HISTORIC AND DESIGN REVIEW COMMISSION

February 20, 2019

HDRC CASE NO: 2019-056
ADDRESS: 310 RIVERSIDE DR
LEGAL DESCRIPTION: NCB 7672 BLK 21 LOT 22
ZONING: C-1, H, RIO-5
CITY COUNCIL DIST.: 3
DISTRICT: Mission Historic District
APPLICANT: Billy Lambert/French & Michigan
OWNER: Joe Gonzalez, Jr., Joe Gonzalez, Jr.
TYPE OF WORK: Exterior modifications, fencing, construction of a pergola structure
APPLICATION RECEIVED: February 01, 2019
60-DAY REVIEW: April 02, 2019
REQUEST:

Building Remodel – 310 Riverside Dr., San Antonio, Texas, 78210

5 SOUTH ELEVATION
SCALE: 1/8" = 1'-0"

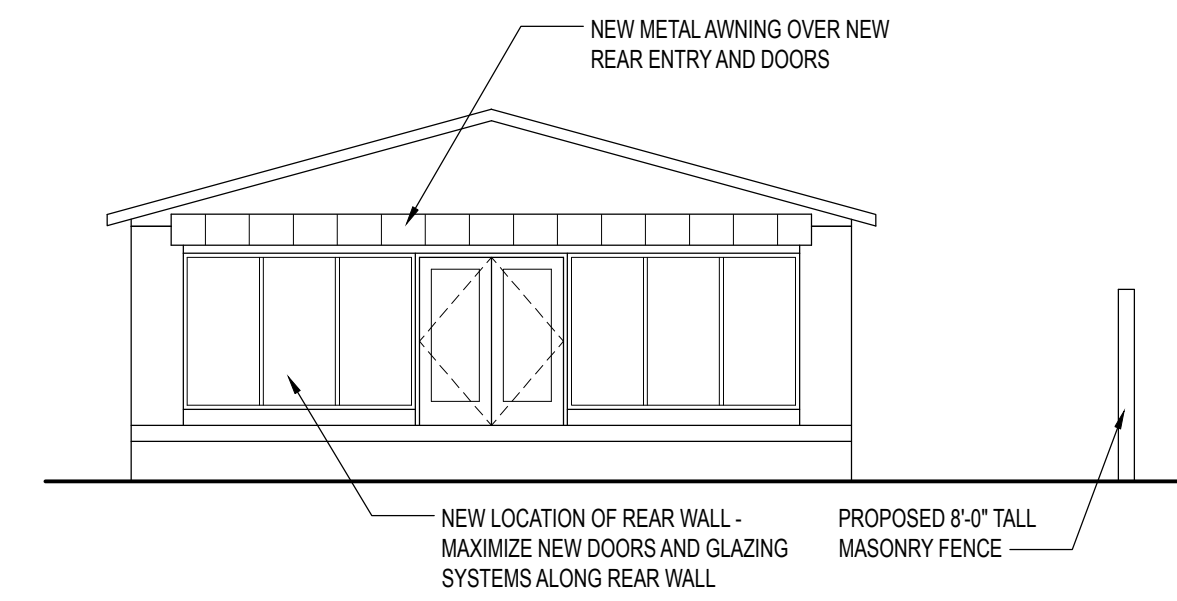
- c. MODIFICATIONS – The applicant has proposed to demolish approximately one-third of the rear of the existing structure, adjacent to the San Antonio River in order to create an outdoor dining area. The portion of the structure that will be removed is an existing rear addition that is not original to the structure. A rear wall will be constructed to enclose the building with new, rear entry doors and glazing. A light weight canopy will be installed to provide shade. Staff finds the proposed modifications as well as the design for the new rear elevation is appropriate.

Staff recommends final approval of items #1 and #2, exterior modifications and the construction of a CMU wall based on findings b through d with the following stipulations:

- i. That the applicant coordinate with the San Antonio River Authority regarding direct access adjacent to the San Antonio River, landscaping and maintenance boundaries and storm water control measures as noted in finding b.
- ii. That the proposed CMU wall not exceed six (6) feet in height and feature a painted or coated appearance as noted in finding d.
- iii. That materials from the demolished section of the structure be salvaged for use throughout the site.

8 CONCEPTUAL TRELLIS ELEVATION
SCALE: 1/8" = 1'-0"

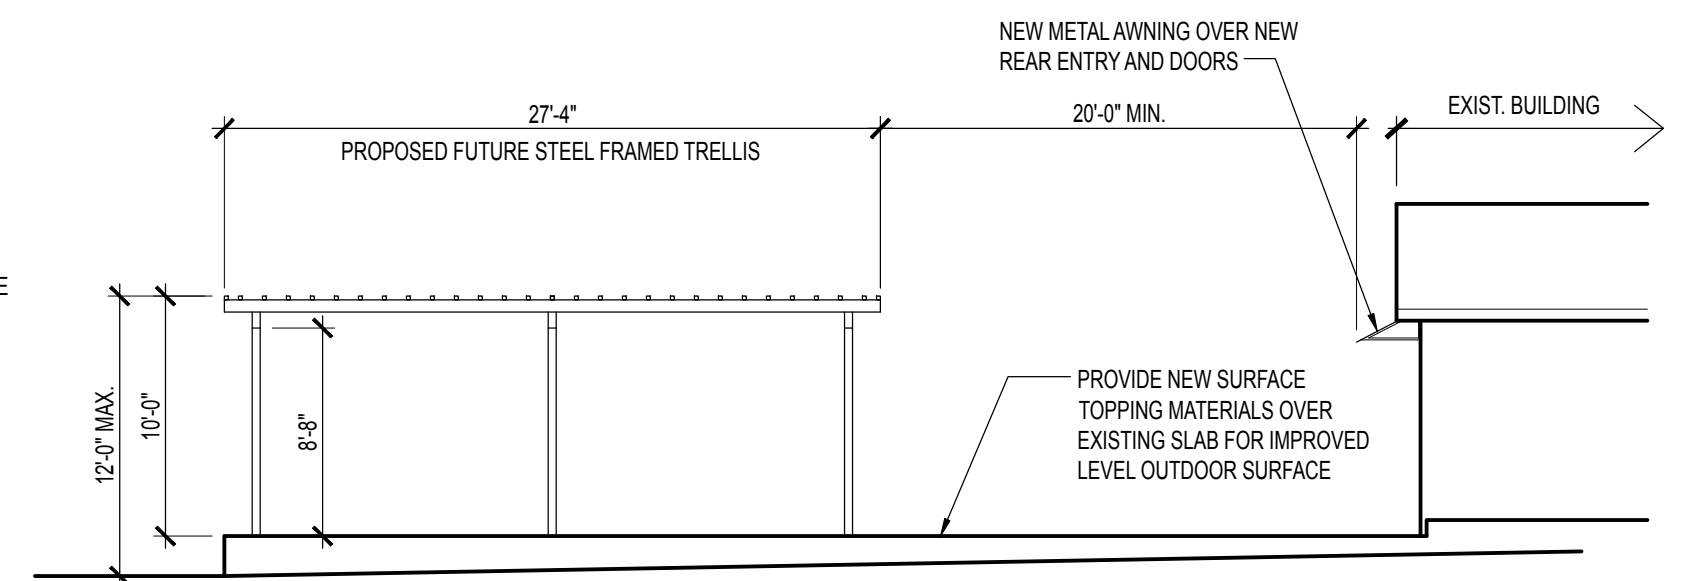
- e. TRELLIS STRUCTURE – The applicant is requesting conceptual approval to construct an open air trellis structure at the rear of the historic structure. The applicant has noted steel framing and an overall height of approximately twelve (12) feet. The proposed structure will be detached from the historic structure. Generally, staff finds the proposed structure to be appropriate. Staff finds that the proposed trellis structure should be painted to not feature metallic finishes.

Staff recommends conceptual approval of item #3, the construction of a rear trellis structure based on finding e with the stipulation that the trellis structure be painted to not feature a metallic finish.
